Report to the Future Melbourne Committee

**Ministerial Planning Referral No. TPM-2010-29/A
54-64 A'Beckett Street, Melbourne**

PLANNING REPORT

MINISTERIAL REFERRAL

Figure 2

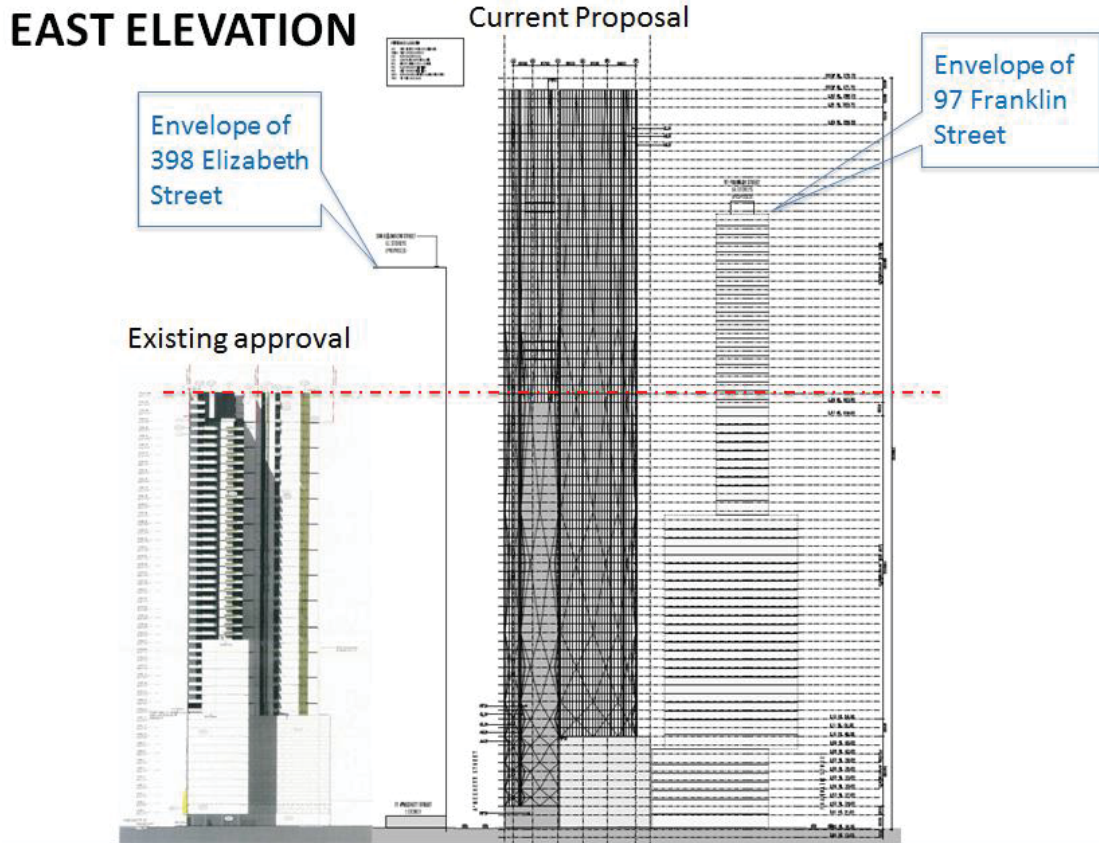
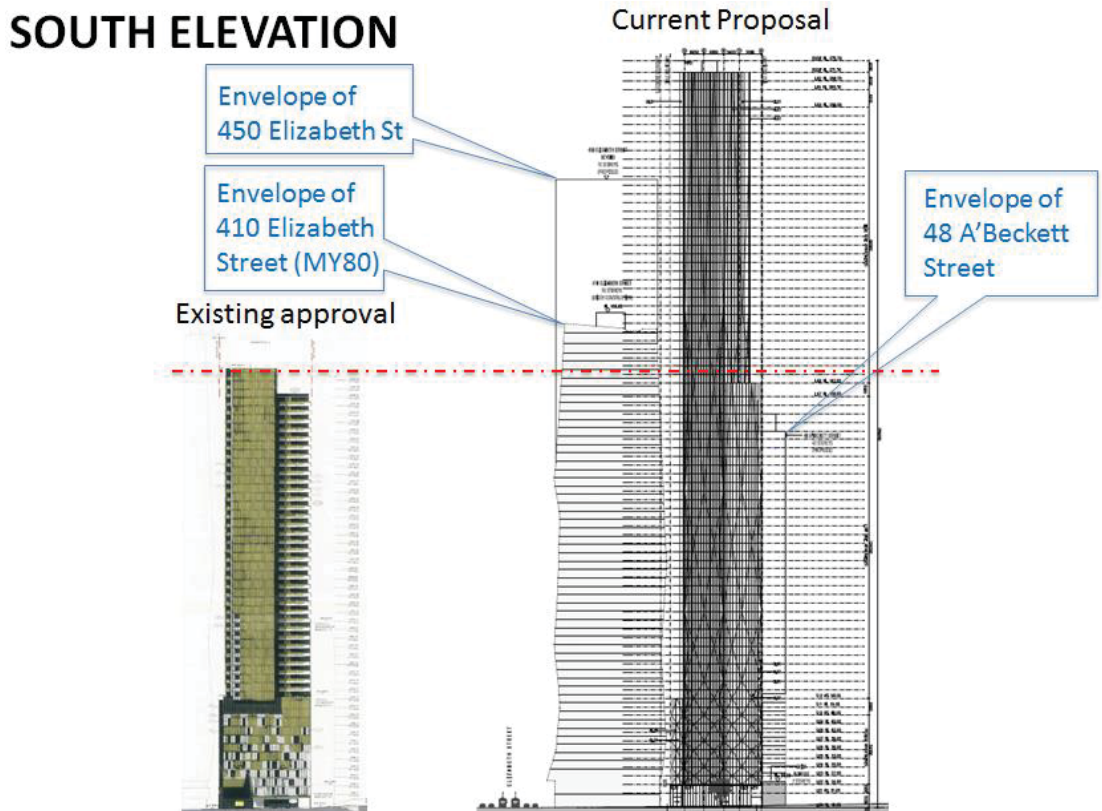
At a height of 259.7m the proposed amended development significantly exceeds the height of recently approved development on a significantly larger lot at 97 Franklin Street (212.5m tall) directly to the north of the site (Figure 2); and nearby sites at 410 Elizabeth Street (Figure 3) and 450 Elizabeth Street which are both corner sites and front an arterial road in Elizabeth Street.

Figure 4

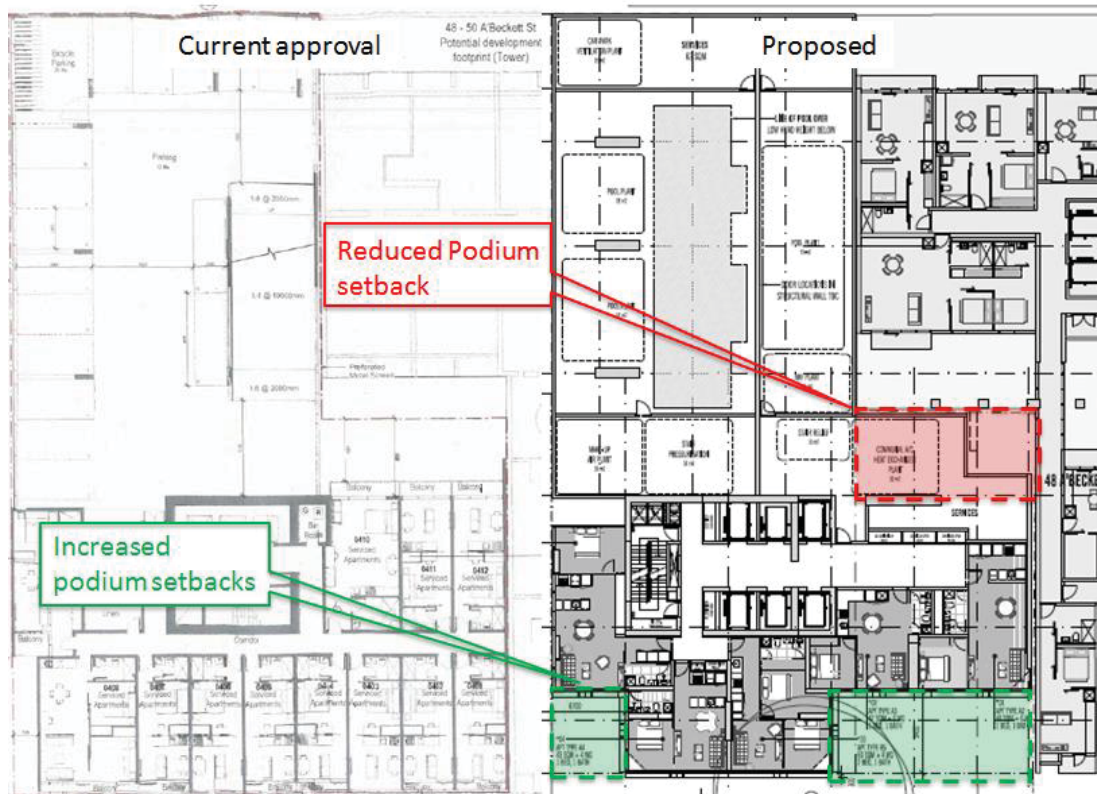
The recommended conditions were not included on the approved permit and the amended proposal seeks to further reduce the approved setbacks compounding this issue with the significant additional height proposed.

PODIUM SETBACKS (Ground floor to level 10)

The proposal fails to provide setbacks and tower separation required by the Local Policy for Urban Design in the Capital City Zone (Clause 22.01) and fails to demonstrate that towers are appropriately offset and habitable room windows do not directly face one another.

Figure 5

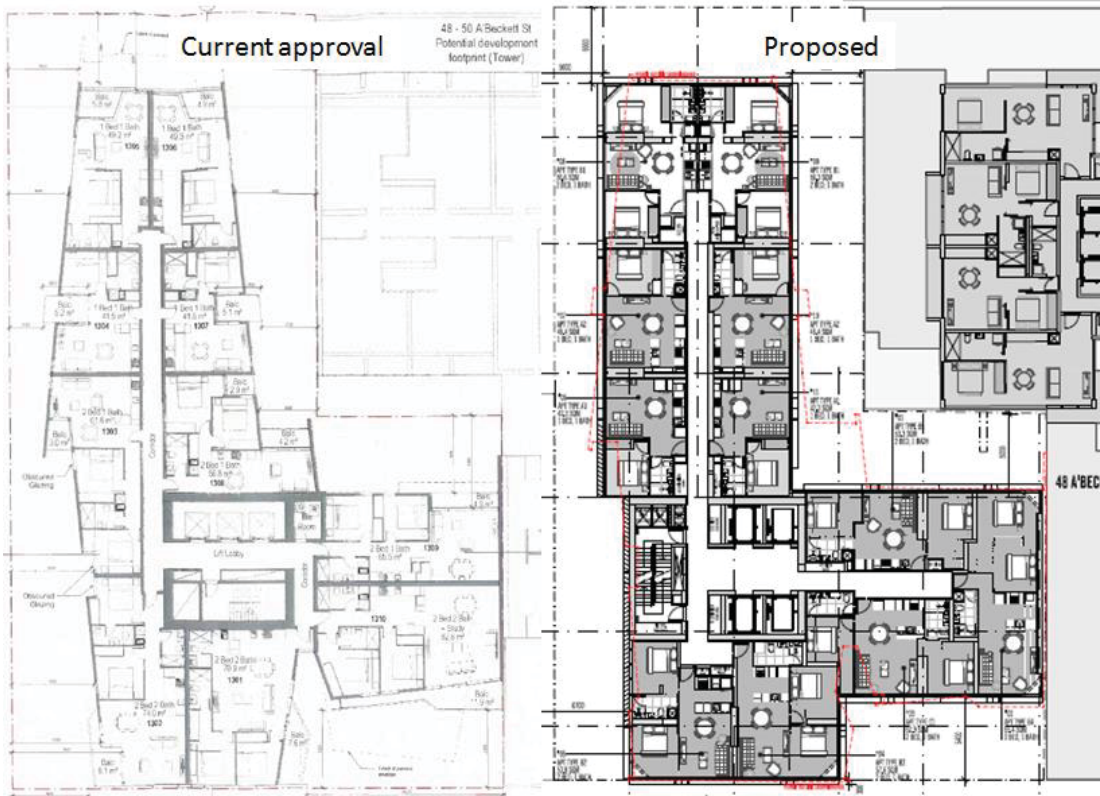
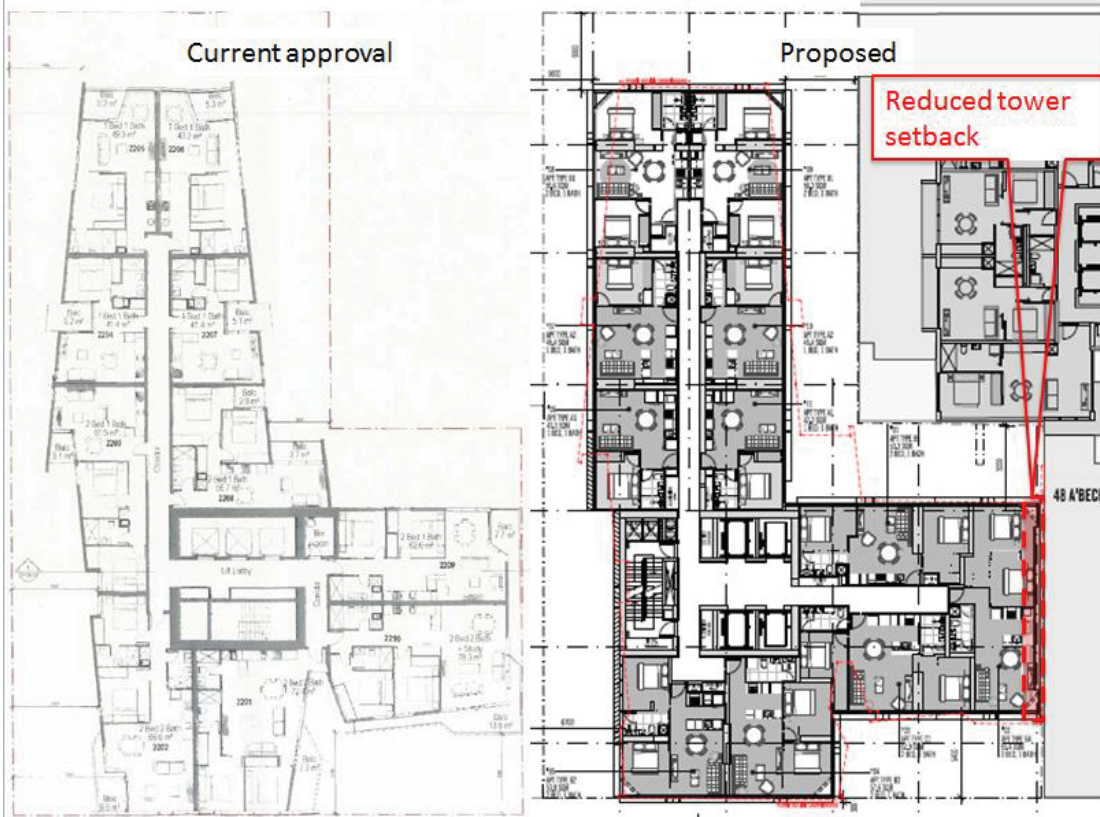
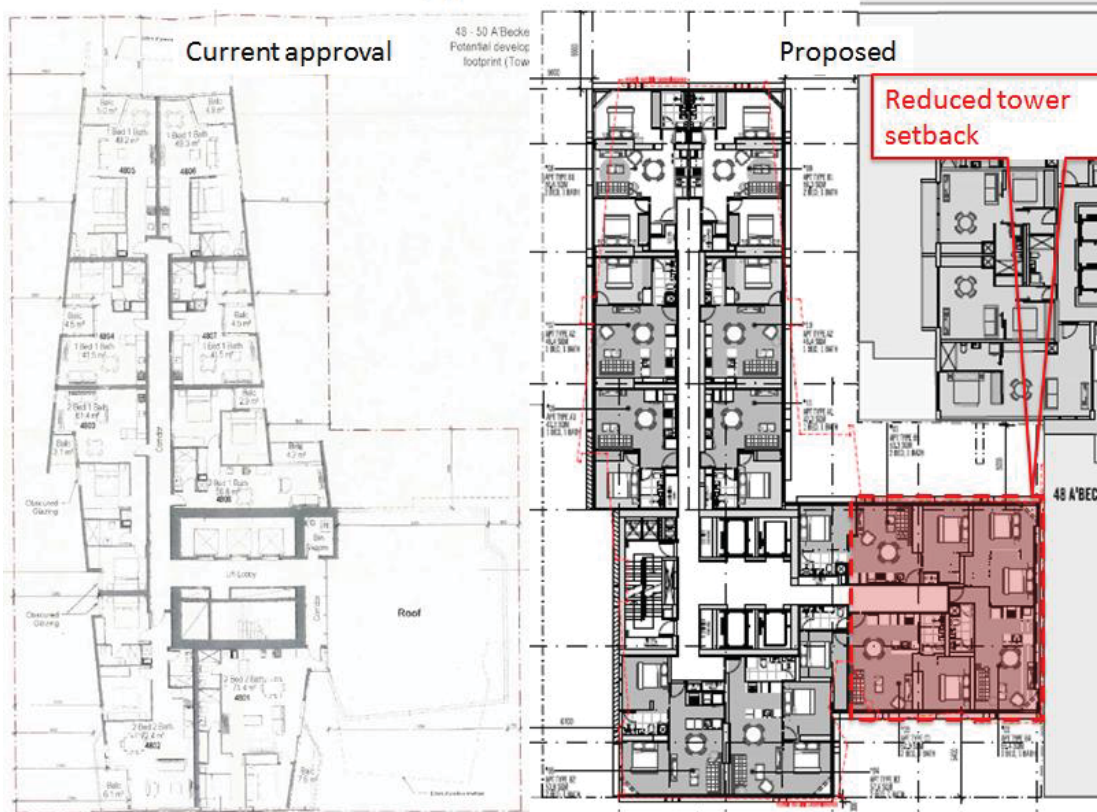
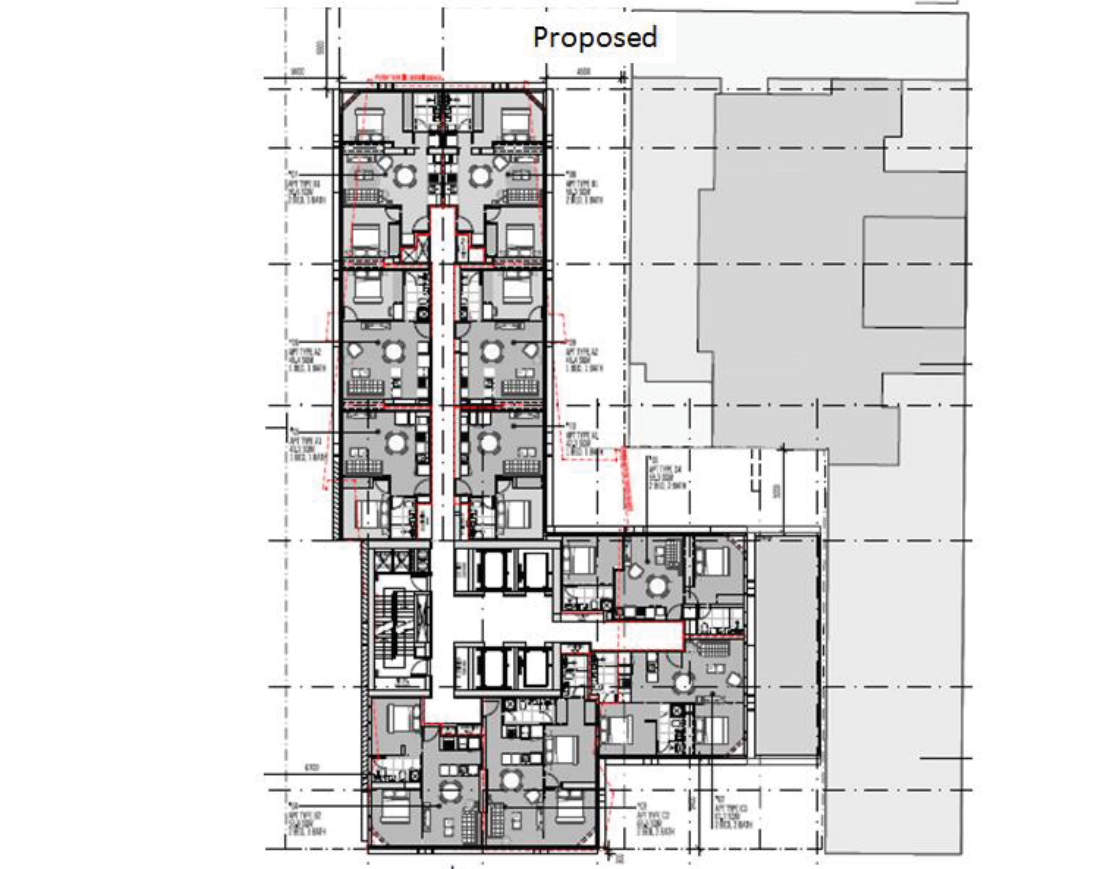
- Setbacks are needed above podium height. Some setbacks are proposed, but on all sides these are less than as set out in Clause 22.01. The tower should be set back at least 10m from A'Beckett St; the proposal has zero setbacks for about half this frontage, which is far from satisfactory and would result in the building having an overbearing impact on the pedestrian's experience.

- The minimal setback from the west boundary (3 to 4m) results in a lack of 'breathing space' between towers; it also limits sun penetration at street level. A similar compaction of towers would occur on the east boundary, where zero setbacks are proposed for a 13m distance.

The amended proposal does not respond to concerns previously raised by the City of Melbourne and further reduces setbacks to the western boundary. The impact of this is compounded by the significant additional height proposed, which results in an unacceptable outcome as it relates to both adjoining sites and the public realm.
